**RESPONSES TO THE TOWN OF NORTHBOROUGH PLANNING REVIEW COMMENTS
DATED APRIL 10, 2024**

**RESPONSES TO THE TOWN OF NORTHBOROUGH SITE PLAN REVIEW COMMENTS
DATED APRIL 11, 2024**

**NORTHBOROUGH
 FIRE STATION
 NORTHBOROUGH, MA**

NOT TO SCALE
 (STORMTRAP CONCRETE VAULT SYSTEM OR APPROVED EQUIVALENT)

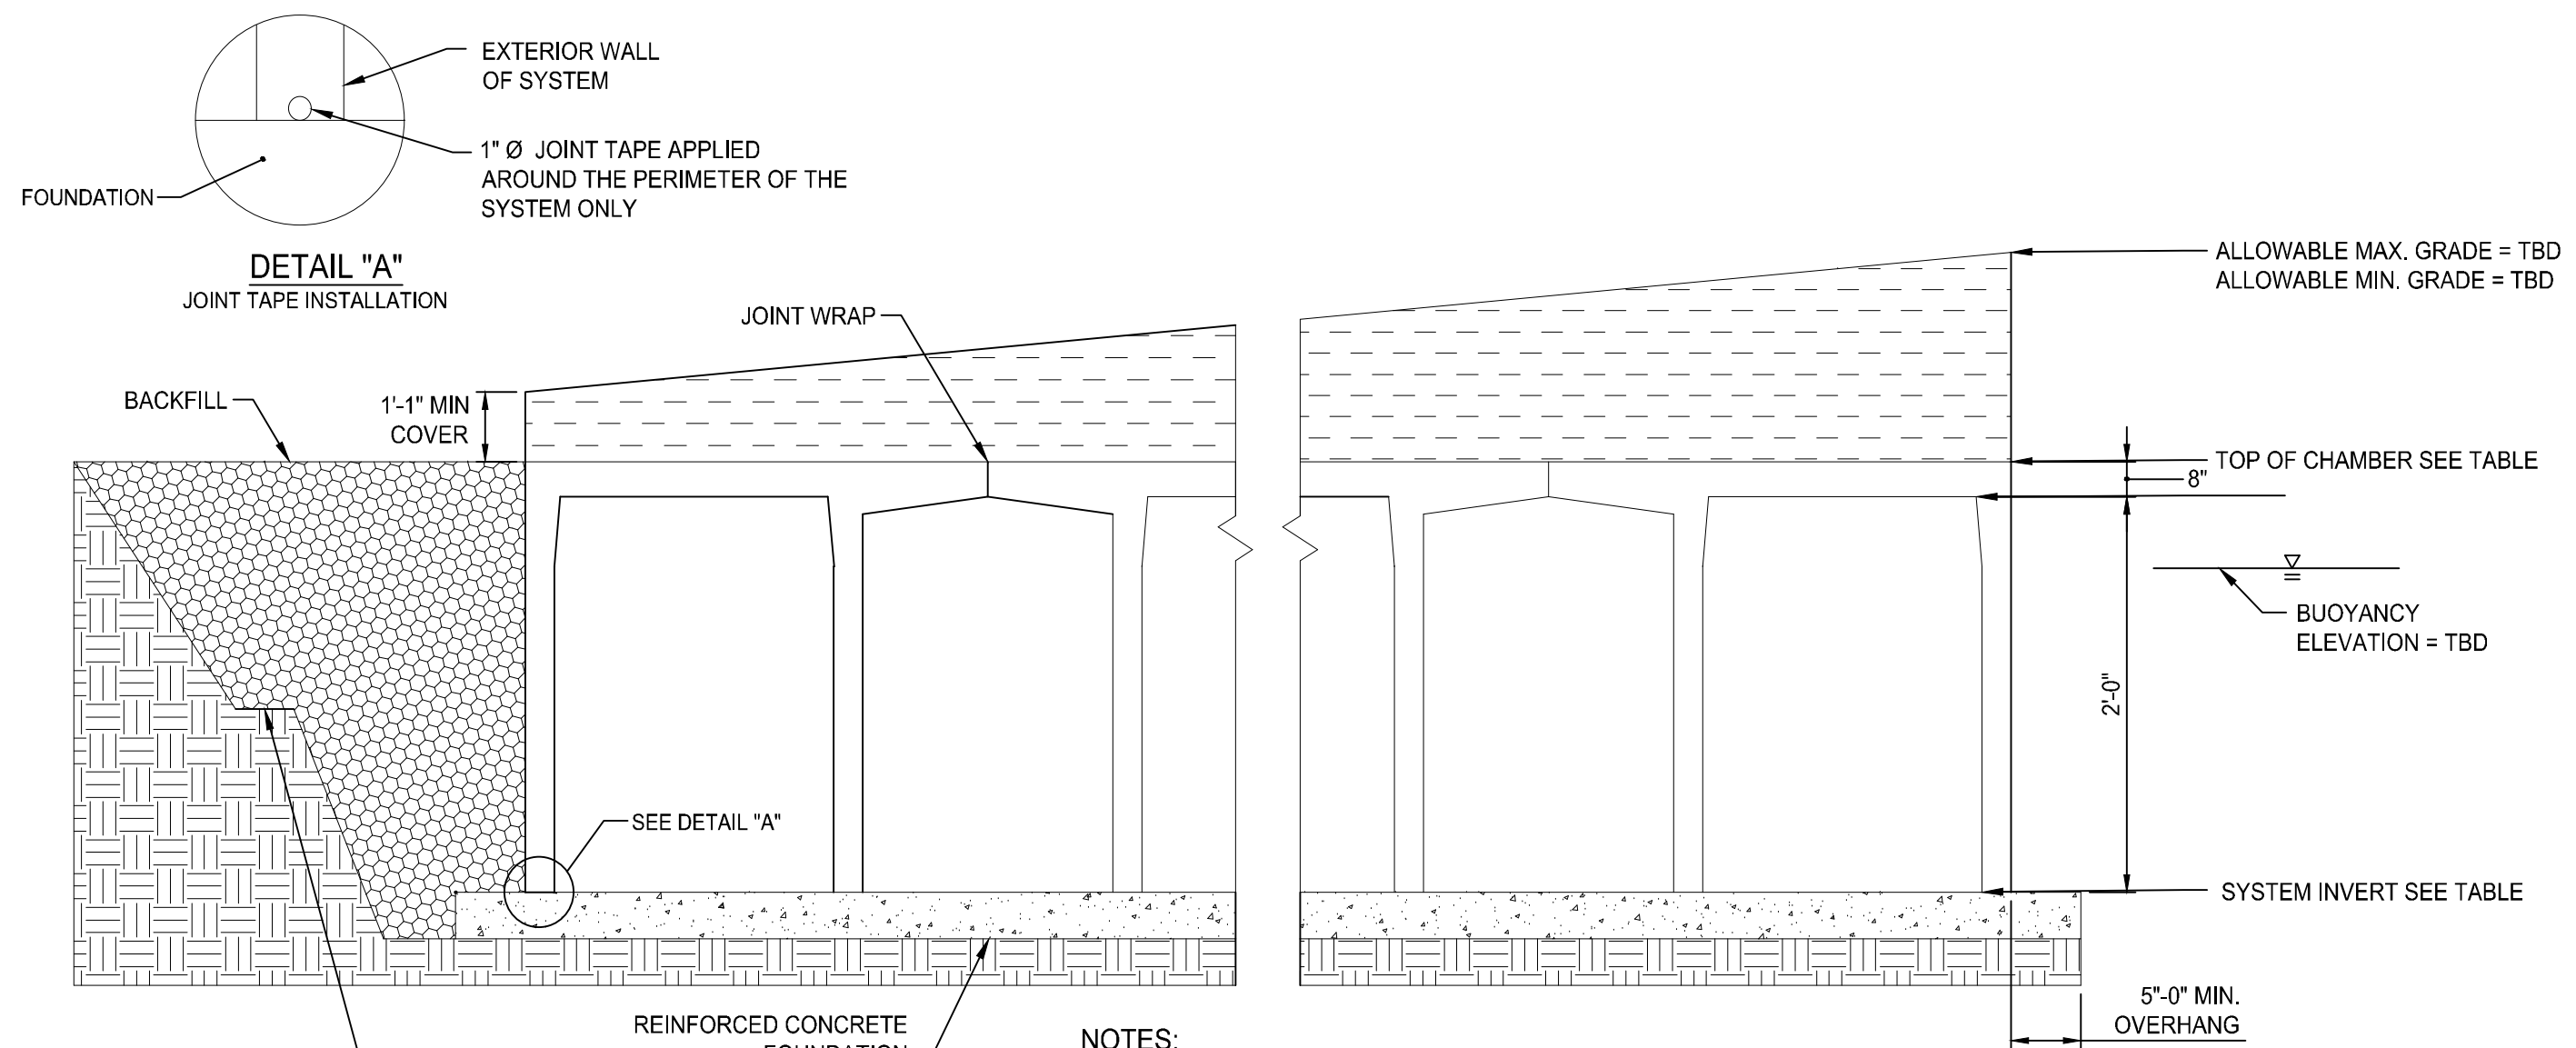
11. **COMMENT:** The plans indicate buoyancy calculations of the underground concrete vault detention system are to be provided by the contractor and I recommend these calculations be provided by the design engineer as a condition of approval.

RESPONSE: *Attached please find buoyancy calculations for the underground concrete vault detention systems. The designer of the selected system shall provide final buoyancy calculations based on the systems selected during construction.*

9 MECHANICAL GATE - DETAIL
SCALE: NTS

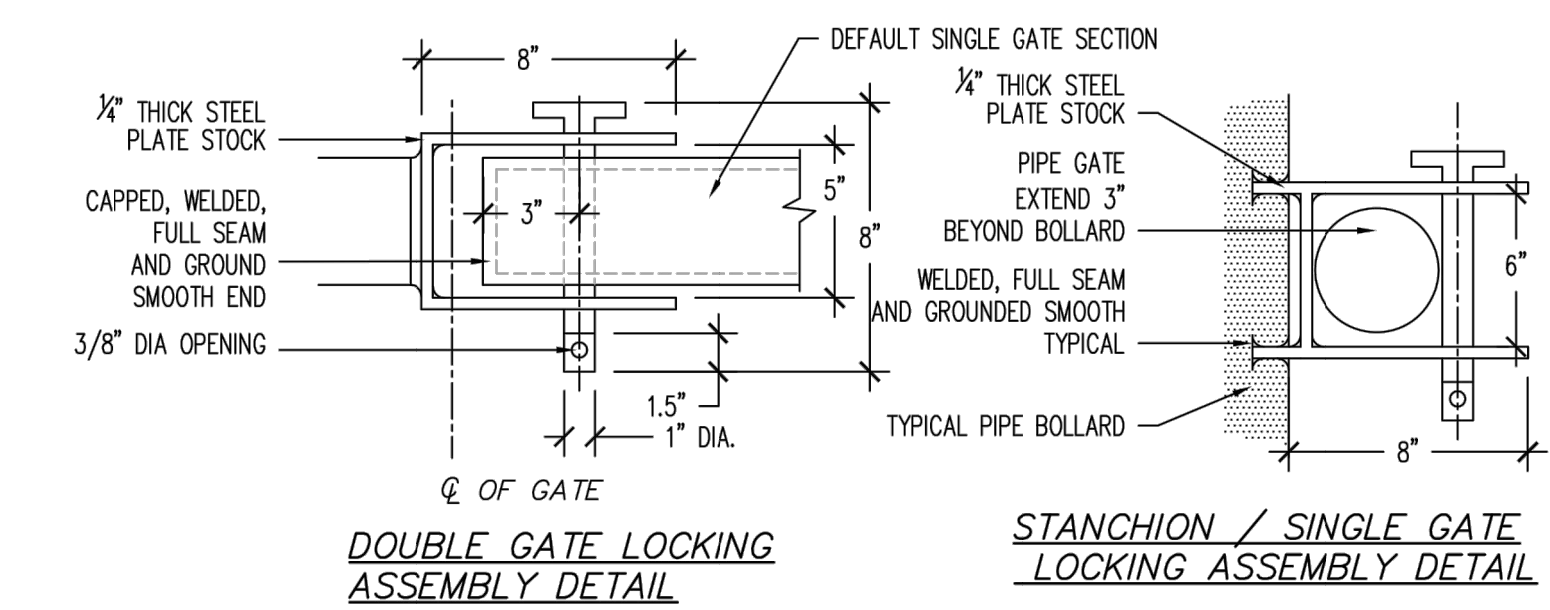
11. **COMMENT:** A detail of the proposed emergency gate should be added to the site plan.

RESPONSE: *The gate proposed at the center of the site between the two parking areas is proposed to be a manual gate. Please see revised Landscape Plan for more information.*

10 DUMPSTER ENCLOSURE - IMAGE
SCALE: NTS

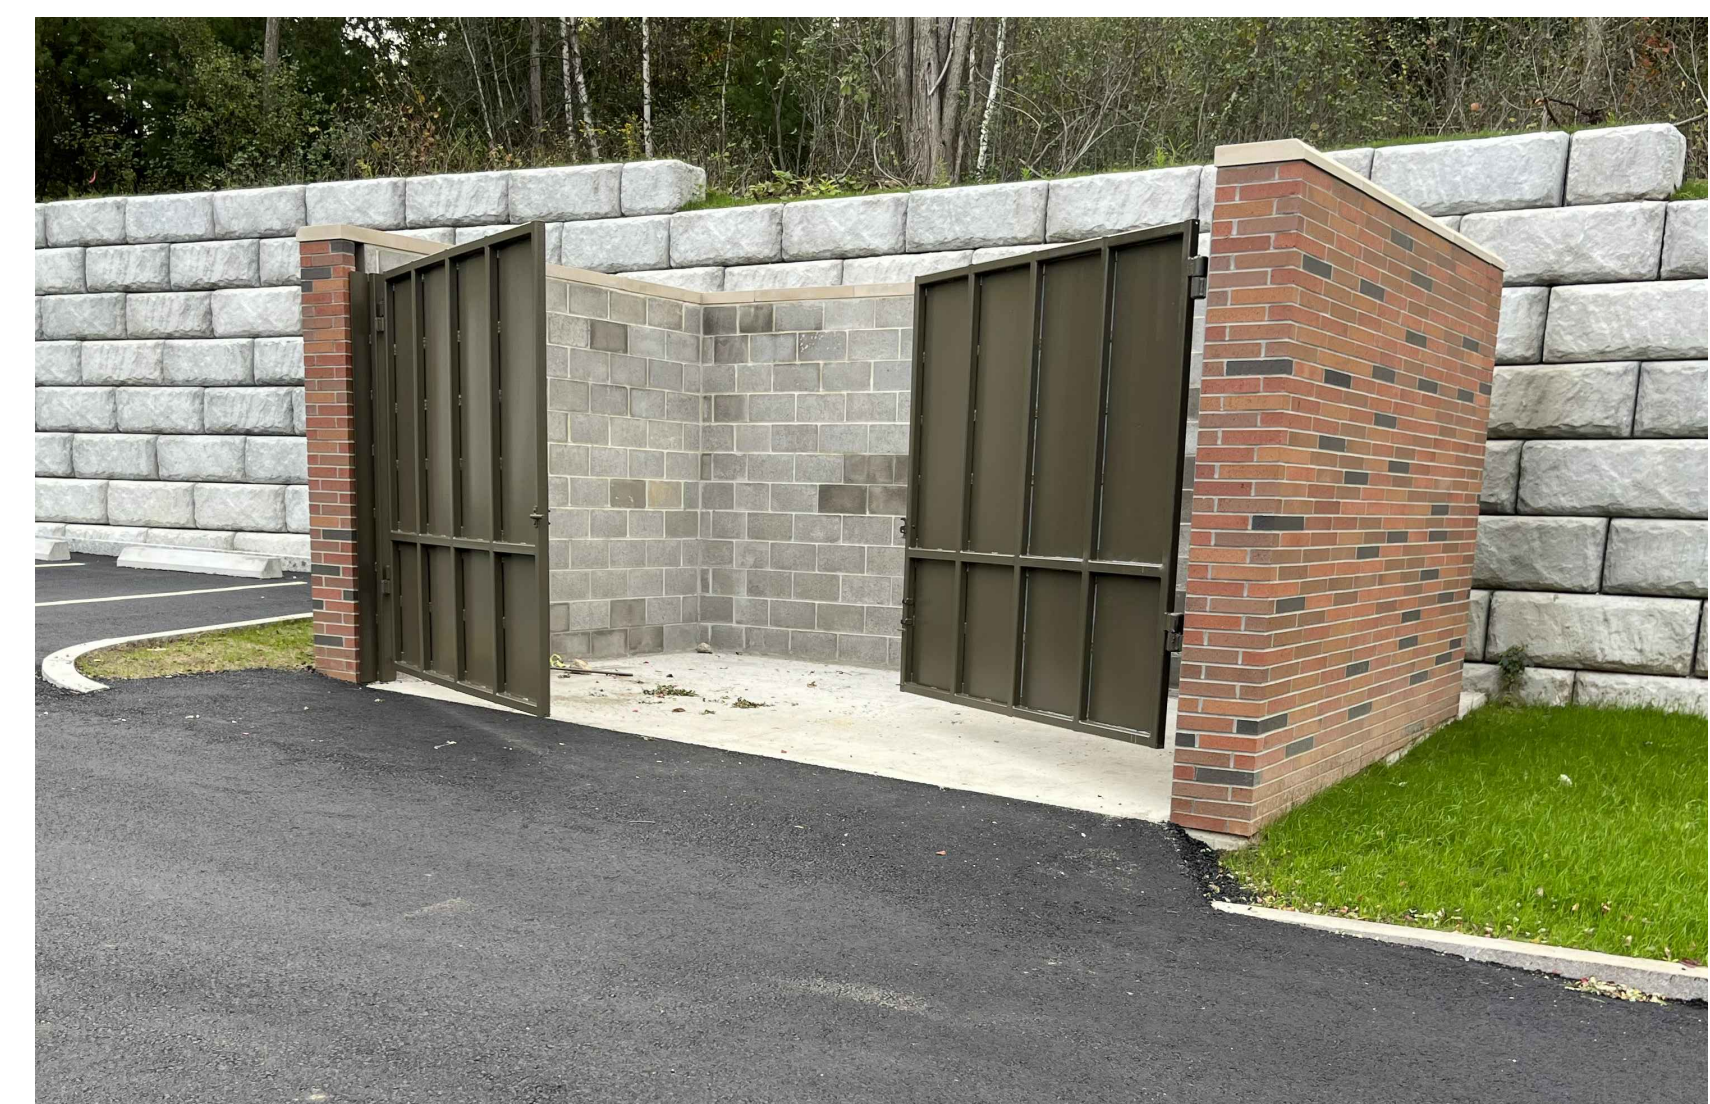
7. **COMMENT:** The landscape plan on Sheet L-1 includes a detail of a fence. Although that fence is appropriate for the top of the retaining wall, the fence around the dumpster should screen the dumpster in accordance with Zoning Bylaw Section 7-09-020C.(d). A stockade or white vinyl fence is preferred over a chain link fence with privacy slats.

RESPONSE: *Please see the revised Landscape Plan for more information on the dumpster enclosure.*

**FIGURE 1:
 SITE LOCUS
 MAP**

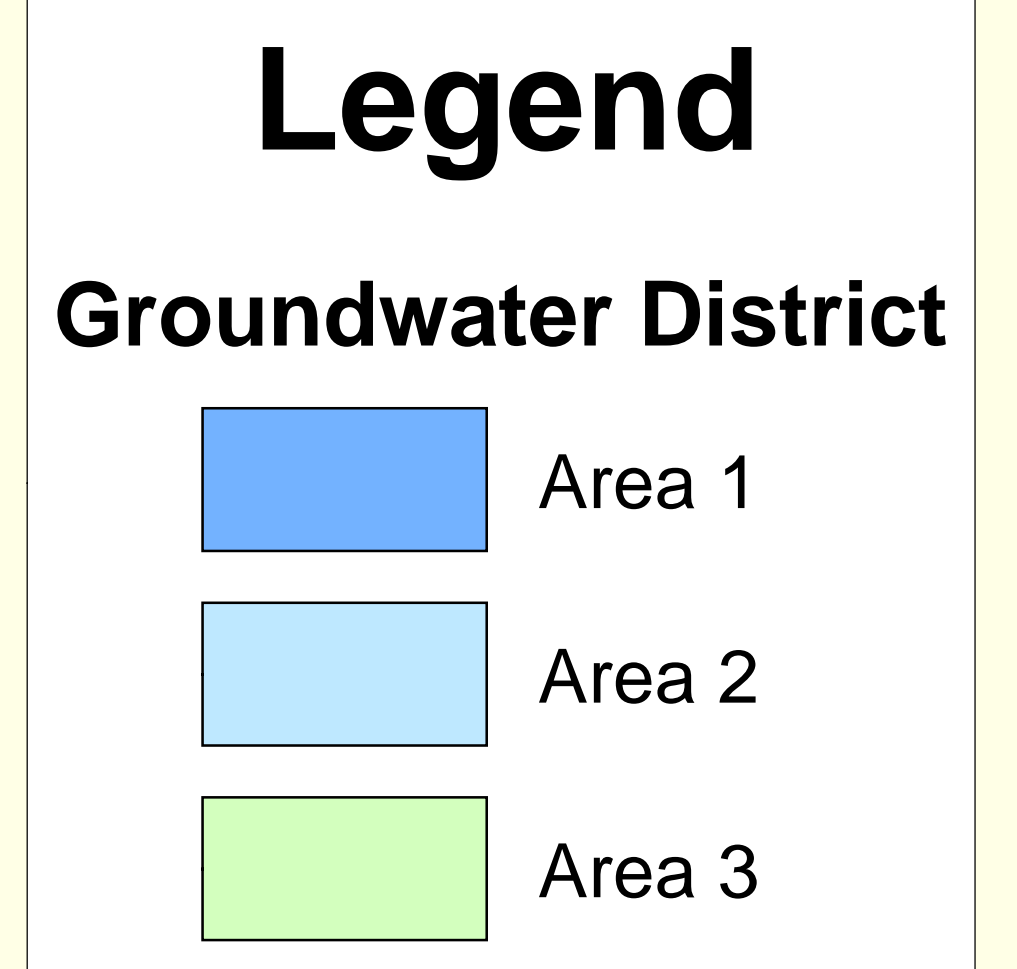
- c. Planning Board Rules and Regulations Section 7.2(C)(4) - Locus plan at the scale of 1"=100' showing the location and use of any building within 300 feet of the boundary of the site and driveway and utilities within 200 feet of the subject property along the frontage street. The submitted locus plan is Not To Scale and does not include utility information. A supplemental land use/land cover plan entitled "Figure 1: Site Locus Map" was submitted, but it also does not provide any information about utilities.

1. **COMMENT:** The application package also included a list of Requested Waivers and there is only one item I would recommend not be granted which is the locus map at a scale of 1" = 100' showing the entire project, the location and use of any buildings within 300 feet of the project boundary. The point of requiring this item is to have a comprehensive discussion during the public hearing regarding potential conflicts with existing driveways in the area. While I understand the emergency vehicles will have priority over all other vehicles it is the entering and exiting of the non-emergency vehicles that should be discussed to minimize conflicts.

RESPONSE: *Item c: An updated site locus map at scale 1" = 100' has been included with this response to comments document. This map includes the location and use of buildings within 300 feet of the project boundary and utility information within 200 feet of the subject property along the frontage. The original waiver requested for the required utility information is retracted.*

RESPONSE: *An updated site locus map at scale 1" = 100' has been included with this response to comments document. This map includes the location and use of buildings within 300 feet of the project boundary and utility information within 200 feet of the subject property along the frontage. The original waiver requested for the required utility information is retracted.*
